RE: **9808 Davenport NW**  
**Grading Plan**  
**Engineer's Stamp Date 6/27/18**  
**Hydrology File: B13D011A**

9808 DAVENPORT, NW  
Grading & Drainage  
Plan

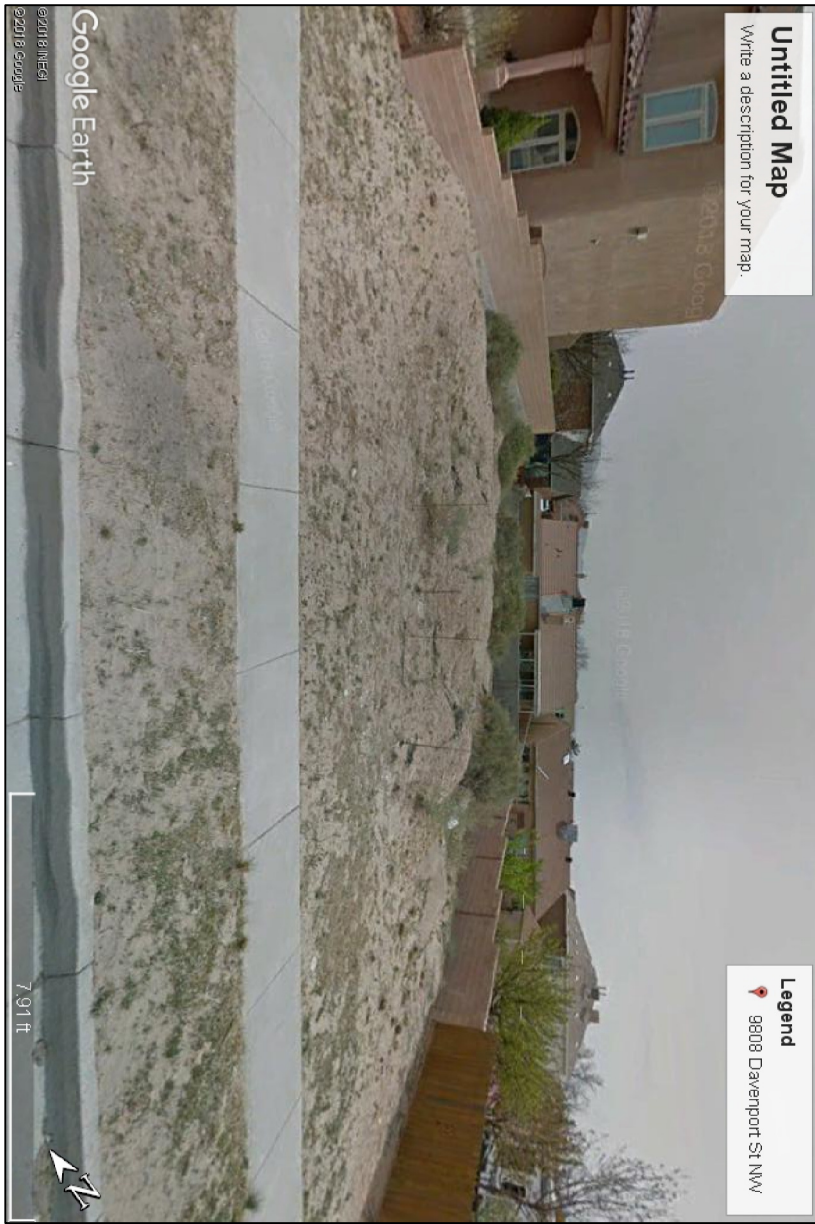
1. Provide a section view through the southern common wall demonstrating that no fill is being placed against it. The existing wall appears to have been constructed as a garden (non-retaining wall). If wishing to fill along the southern edge of the property, a new retaining wall inset from the property line will need to be constructed. Alternatively, consider a stem wall integral with the house to elevate the pad/slab to elevation ~5187'.

2. First flush retention is no longer required on single residences; the ponds may be removed if desired.
3. This area was master planned under SAD-226 and an inlet was provided in the backyard in order to drain the entire lot. No attempt needs to be made to drain the lot to the road; the entire lot may drain to the backyard and into the provided inlet.

4. Increase the density of existing and proposed spot elevations and provide existing and proposed contours. Demonstrate that care is taken in grading near the property lines in accordance with the *DPM Chapter 22.5 Parts A & B*.
